REF. : H-P-ASP-MN-5081_iss 2	
				SPIRE Progress & Interface	
				DATE : 30/06/04	PAGE : 1/34
COMPTE RENDU DE REUNION / MINUTES OF MEETING				LIEU / PLACE : RAL Chilton	
OBJET / PURPOSE :			CLASSIFICATION :		
SPIRE Progress & Interface Meeting					
PARTICIPANTS ATTENDEES	SOCIETE FIRM	SIGNATURE SIGNATURE	PARTICIPANTS ATTENDEES	SOCIETE FIRM	SIGNATURE SIGNATURE
Guy Doubrovik	ASP		John Delderfield	RAL	
Bernard Collaudin	ASP		Eric Sawyer	RAL	
Carsten Scharmberg	ESA		Doug Griffin	RAL	
Horst Faas	ASED		Bruce Swingyard	RAL	
Marco Cesa	ALS				
REDACTEUR / WRITTEN BY :					
Bernard Collaudin					
CONCLUSION :					
DISTRIBUTION : PARTICIPANTS / ATTENDEES	POUR ACTION : FOR FURTHER ACTION				
	POUR INFORMATION : FOR INFORMATION				
APPROUVE PAR / APPROVED BY					
NOM / NAME					
SIGNATURE / SIGNATURE

See in annex 4 table from file " SPIRE IIDB 3.3 inputs_GD_23-06-04.xls", With included SPIRE comments (from file sent 30/06 by JD), discussed during meeting

2K inter-box strap

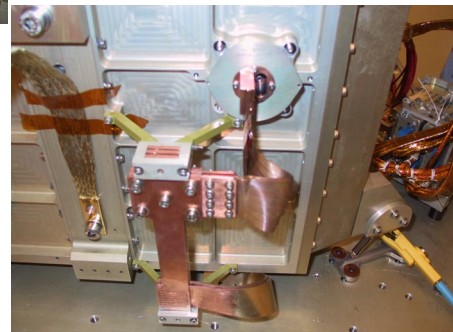
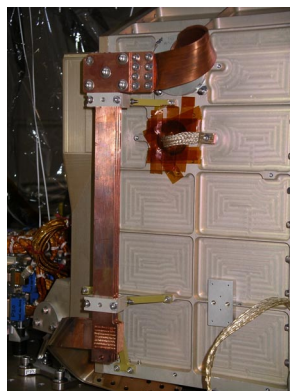
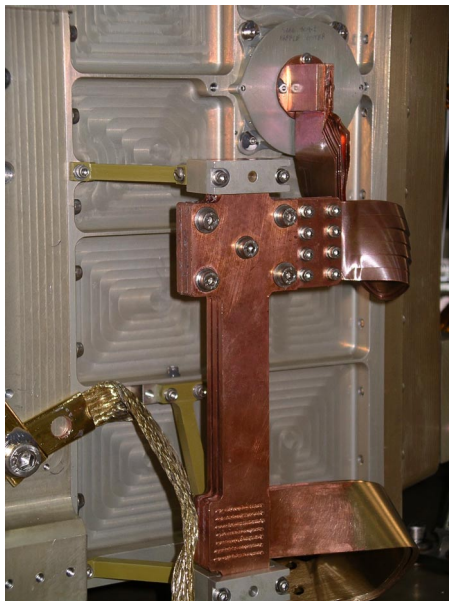
2K interbox straps poor due to copper/ Aluminium contact → use AL-CU welded joints.

- High Delta T recorded during cold test
- Strap redesigned to improve performance
- Large area bonded copper to aluminium joints
- This doubles up as electrical isolation joints as well
- Bolted copper to copper joints
- Design complete, parts manufactured, currently being annealed, then gold plating, then assembly.

CFRP feet

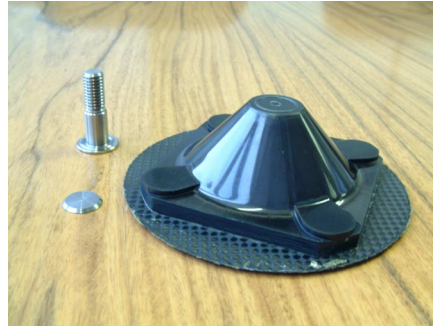
CRFP feet: FPU model broke during vibration unit test (on top of cone): under redesign

- Detector box and FPU test units manufactured and tested
- All cold strength tested
- All passed except FPU cone
- Broke below estimated load at bolt cone interface
- Some redesign required.
- All other released for manufacture.
